SCHWEIZER SERVICE BULLETIN

B-296
05 Jan 2011

SUBJECT: CLEVIS PIN CHAFFING BOTTOM OF FUEL TANK

MODELS AFFECTED: • All Model 269C Helicopters

Figure B-296-1. Clevis Pin

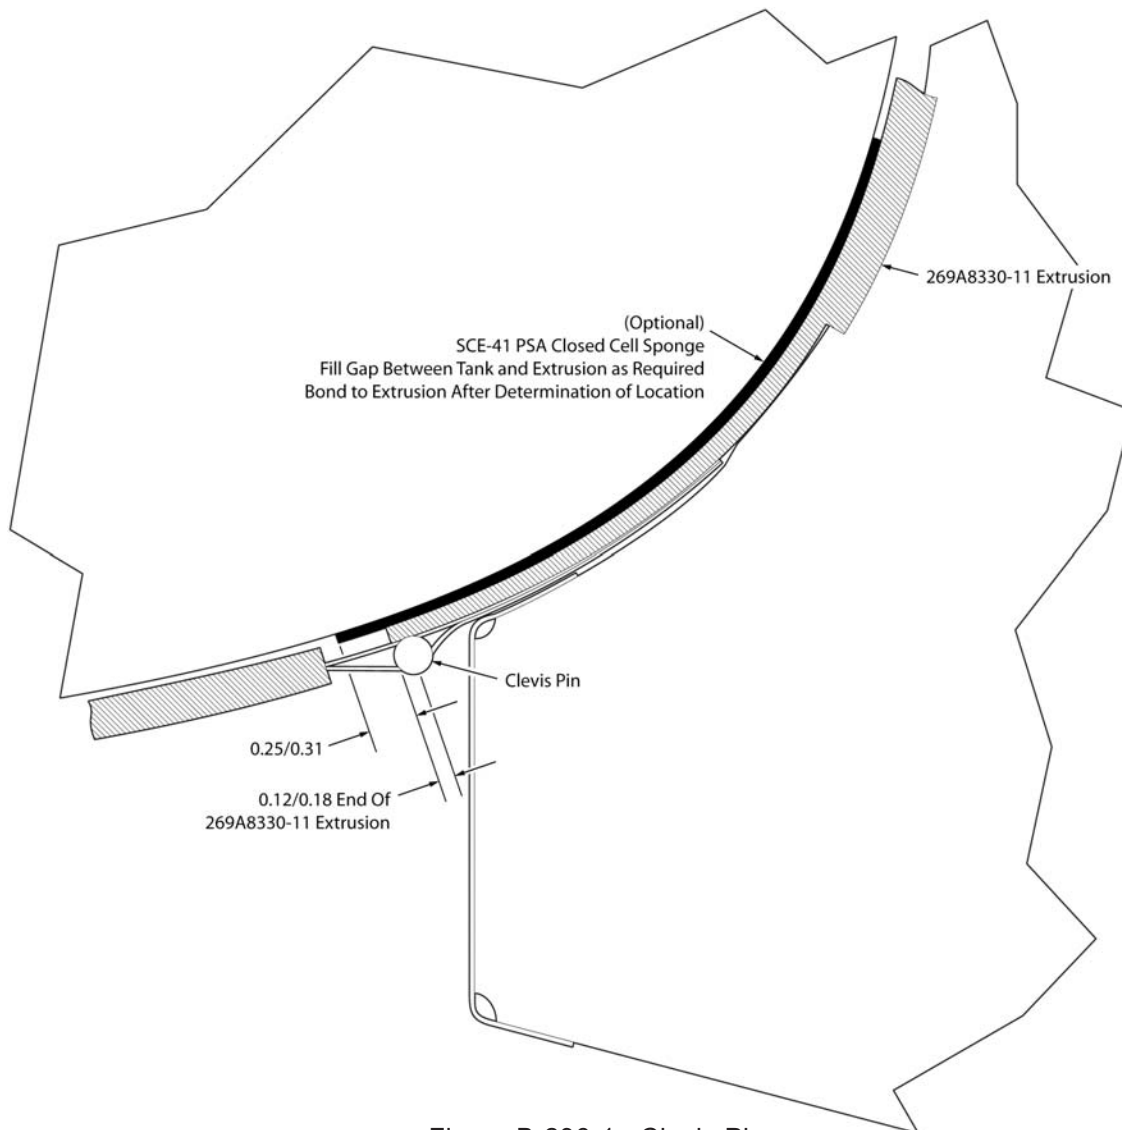
PREFACE: • Schweizer Aircraft Corp. has received several reports that the heads of the clevis pins and washers, attaching the lower half of the fuel tank retention strap (band clamp) to the airframe, are chaffing the bottom of the tank. Investigation of the condition revealed that the rubber extrusion was not properly positioned between the fuel tank and strap attachment. The extrusion holds the strap away from the fuel tank and prevents the strap and pin assembly from contacting the tank. This Service Bulletin requires a one time inspection to assure the extrusion is properly positioned and chaffing has not occurred.

- a. Using a bright light and mirror, examine bottom of fuel tank and check that 269A8330-11 rubber extrusion is properly positioned between tank and retention strap clevis pin as shown in Figure B-296-1. Verify there is proper clearance between the clevis pin head, washers and fuel tank. Clearance needs to be verified after the fuel tank is fueled.

- c. Remove installed 269A8330-11 extrusion from seat structure vertical beam. Using MEK, remove all residual adhesive.
- d. Trial fit a new length of 269A8330-11 extrusion on the seat beam and trim to .12 to .18 inch past the center line of the clevis pin position as shown in Figure B-296-1. Using waterproof cement, bond extrusion to vertical beam and portion of stainless steel strap attached to vertical beam.

- e. Reinstall fuel tank on helicopter in accordance with Basic HMI, Section 5.
- f. Check for proper clearance of clevis pin head. Verify clearance after fuel tank has been fueled. If there is not adequate clearance, repeat Step b. above and add additional layers of SCE-41 PSA Closed Cell Sponge, as required, as shown in Figure B-296-1.
